Lower Wisconsin River Watershed
Comment Form

Comment pertains to:
DFIRM Panel # 550522 0150 A **Comment #** 1 **Other** _____

FOR COMMENT #1

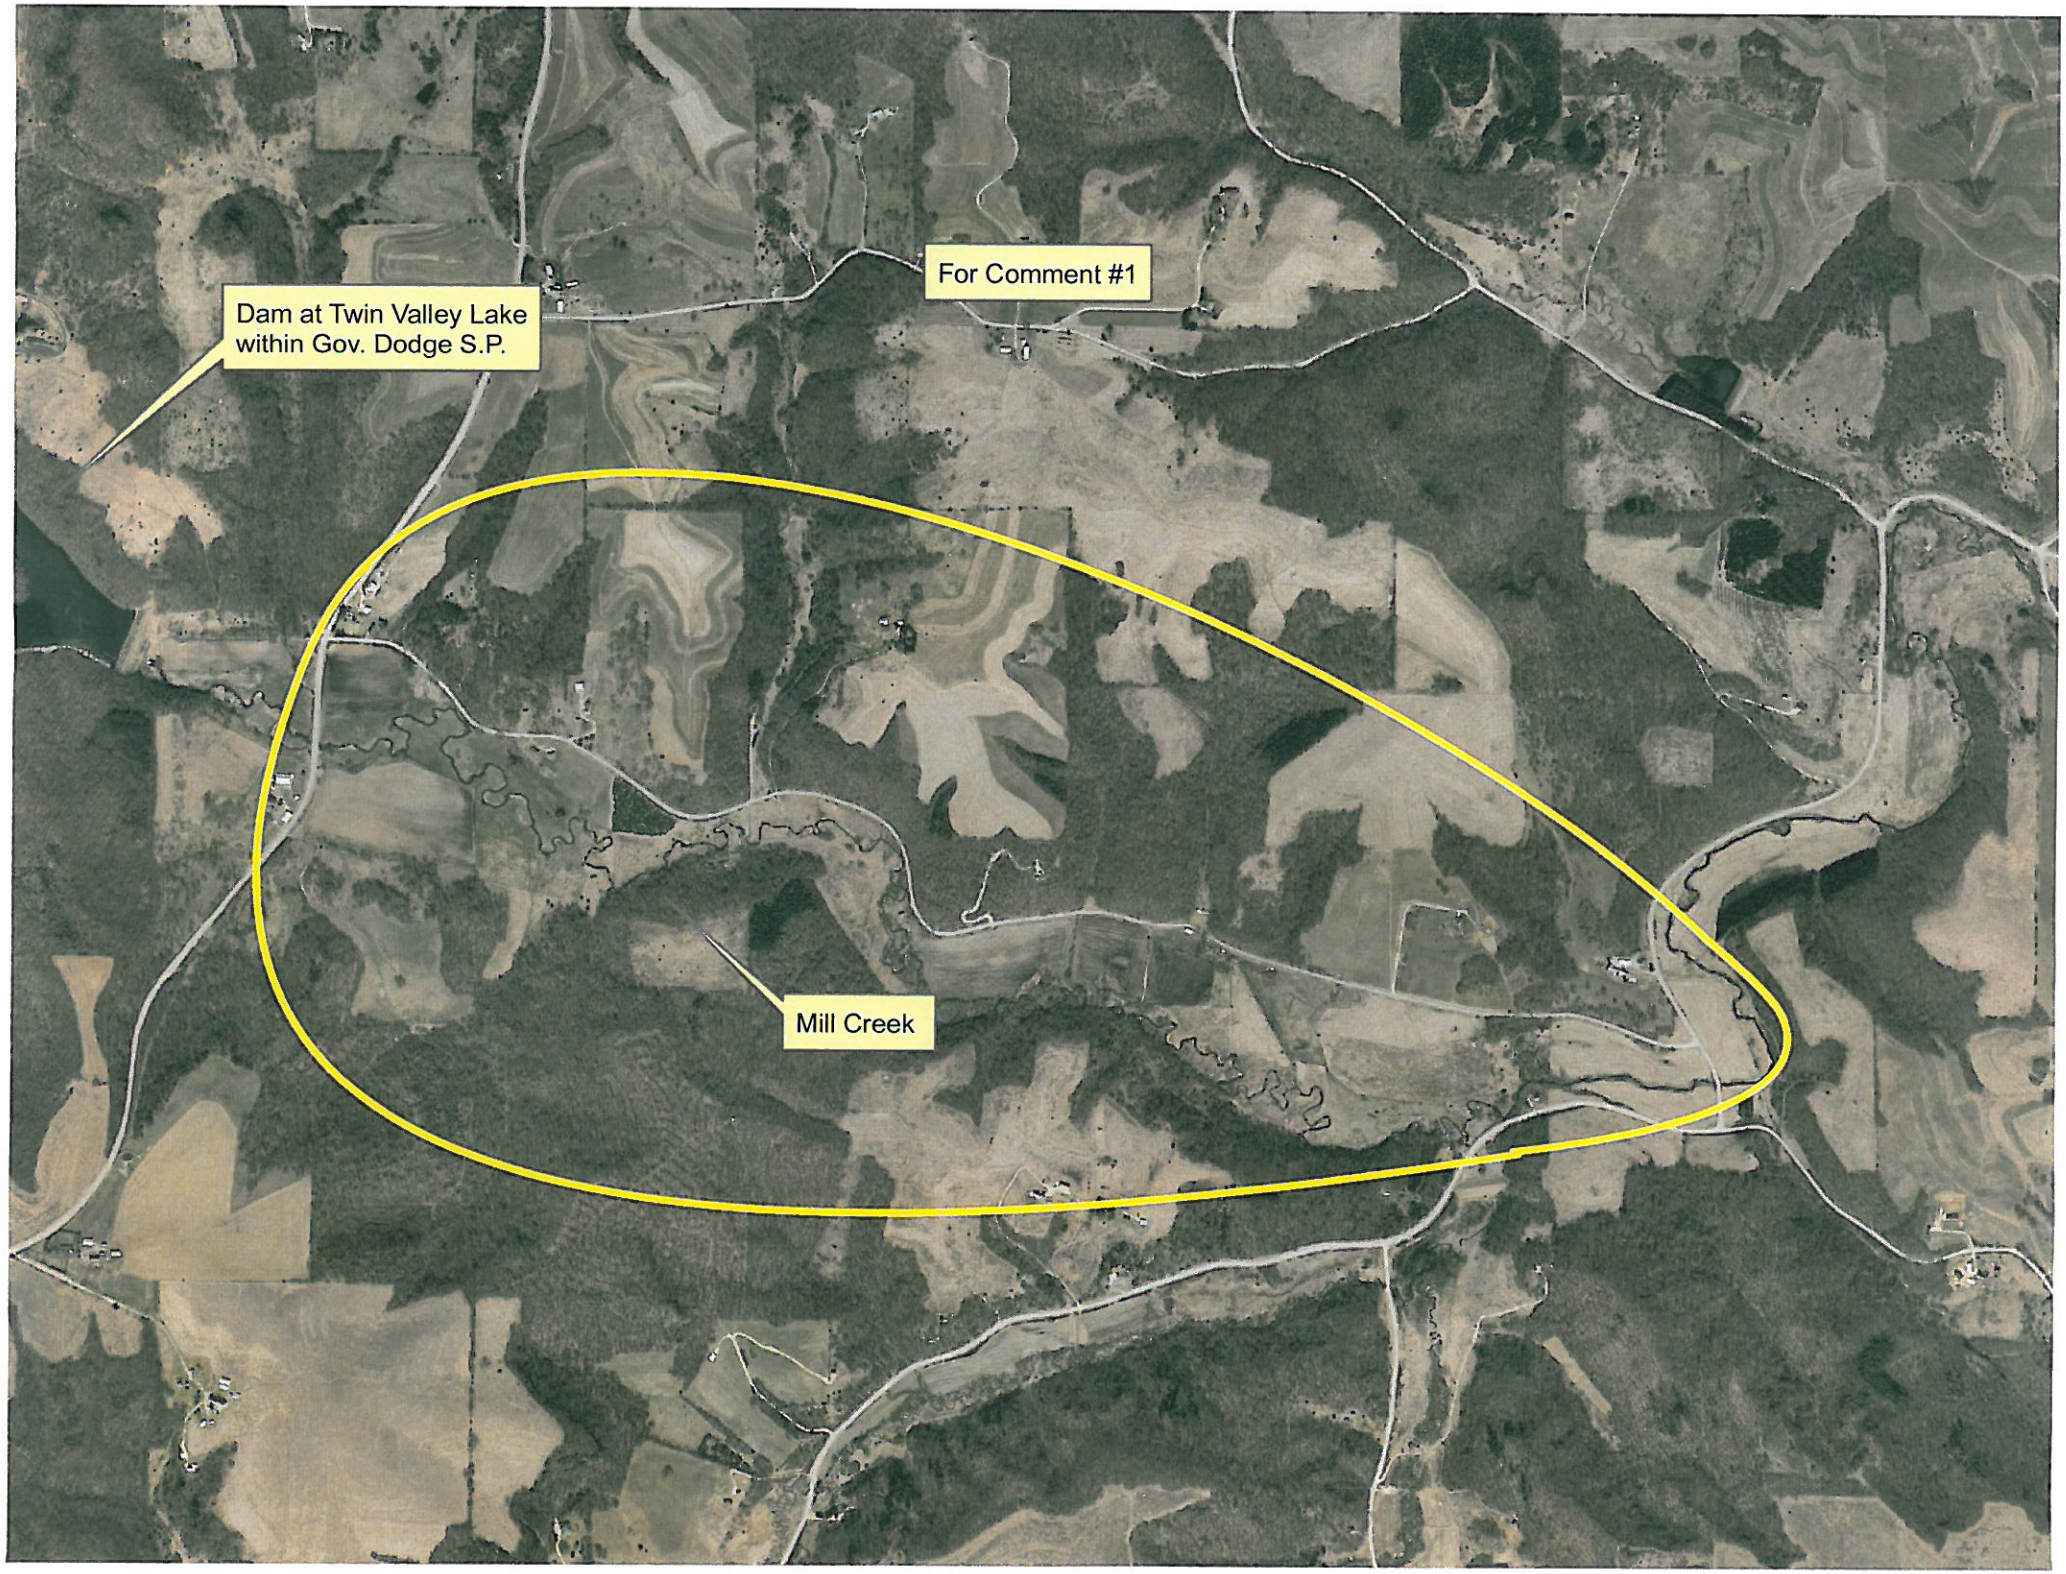
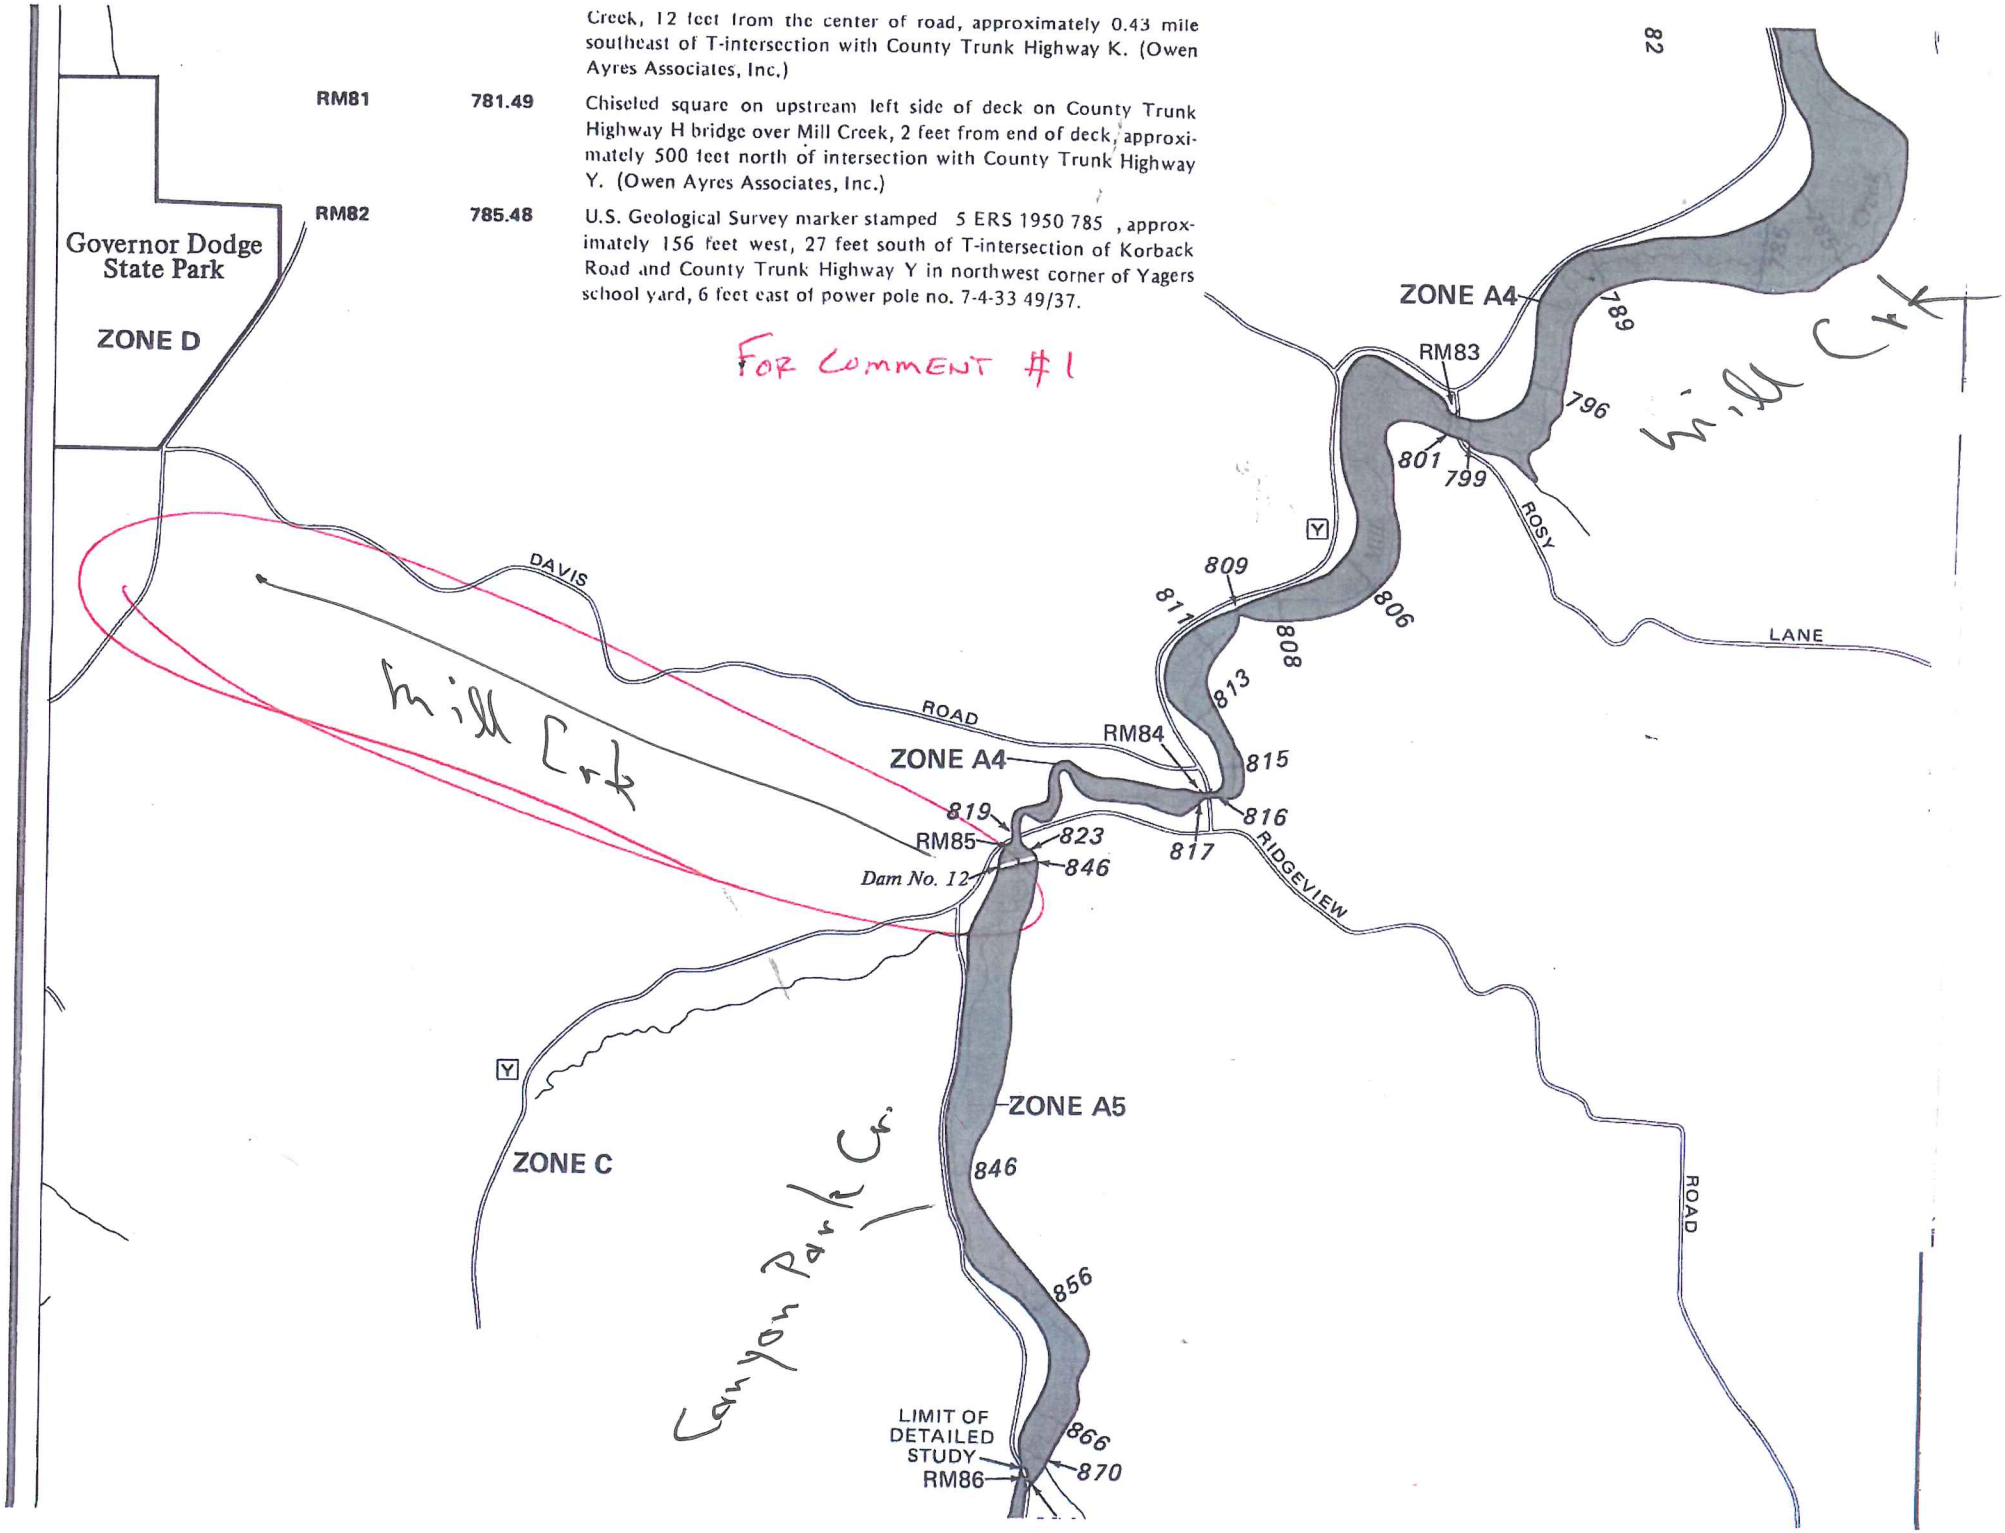
Comment pertains to:			
☐	EFFECTIVE STUDY NO LONGER REFLECTS EXISTING CONDITIONS	☒	APPROXIMATE STUDY OR NO STUDY ON A STREAM WHERE DEVELOPMENT IS OCCURRING OR LIKELY TO BE
☐	AREAS OF REOCCURRING FLOODING OUTSIDE OF MAPPED FLOODPLAIN		
☐	AREAS WITH CLUSTERS OF LOMC	☒	OTHER: FAILURE TO SHOW CREEK

MILL CREEK WAS/IS ABSENT ON THIS PANEL AS IT FLOWS FROM GOV. DODGE STATE PARK ADJACENT TO DAVIS ROAD. THE COUNTY HAS DAM SHADOW/BREACH DATA. THERE IS DEVELOPMENT ADJACENT TO CREEK.

Comment #2

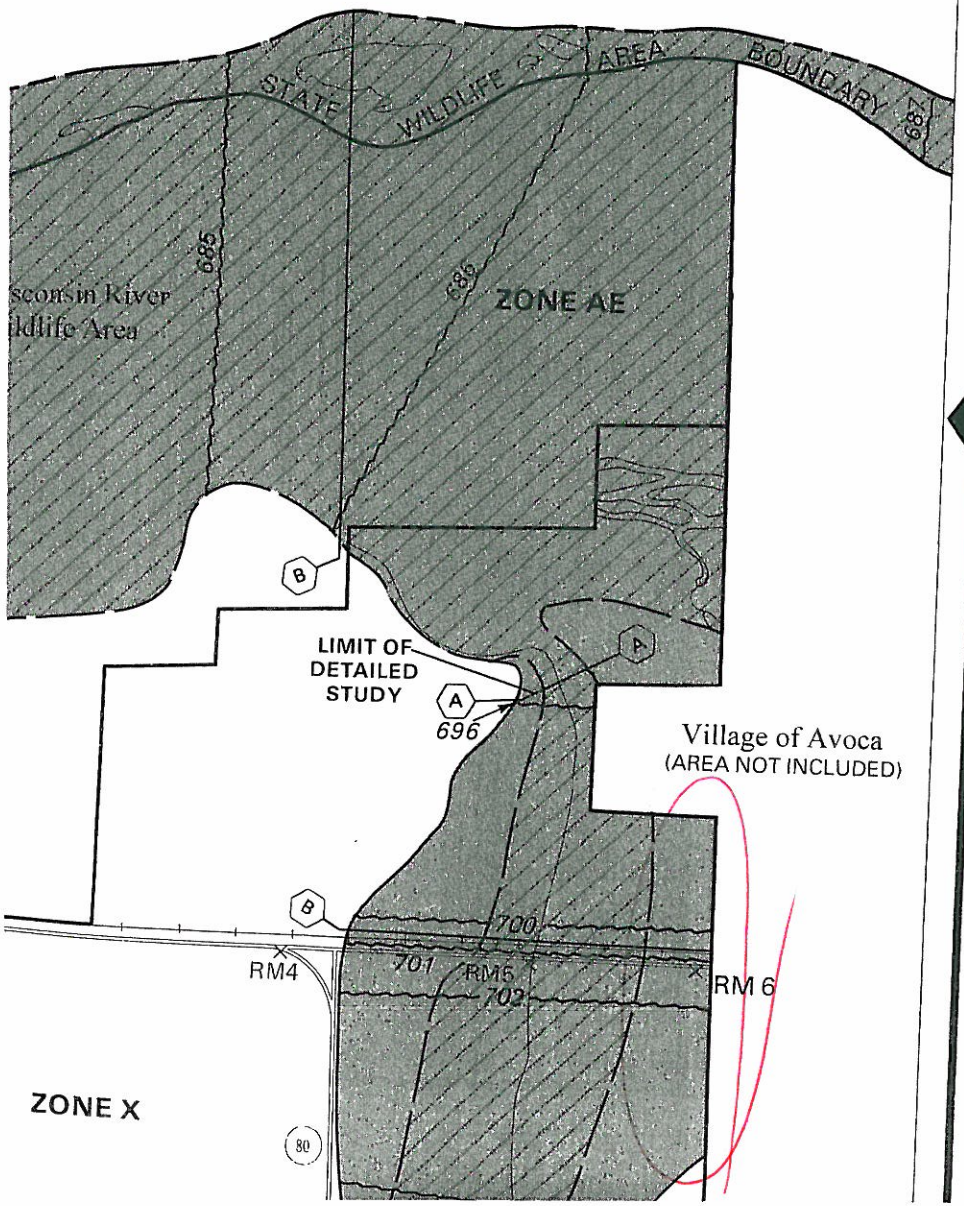
Comment pertains to:			
☒	EFFECTIVE STUDY NO LONGER REFLECTS EXISTING CONDITIONS	☐	APPROXIMATE STUDY OR NO STUDY ON A STREAM WHERE DEVELOPMENT IS OCCURRING OR LIKELY TO BE
☐	AREAS OF REOCCURRING FLOODING OUTSIDE OF MAPPED FLOODPLAIN		
☐	AREAS WITH CLUSTERS OF LOMC	☐	OTHER:

RECENTLY CONSTRUCTED BERM ALONG WEST EDGE OF VILLAGE OF AVOCA (2010-2011) EFFECT OF MORREY CREEK NOT KNOWN.
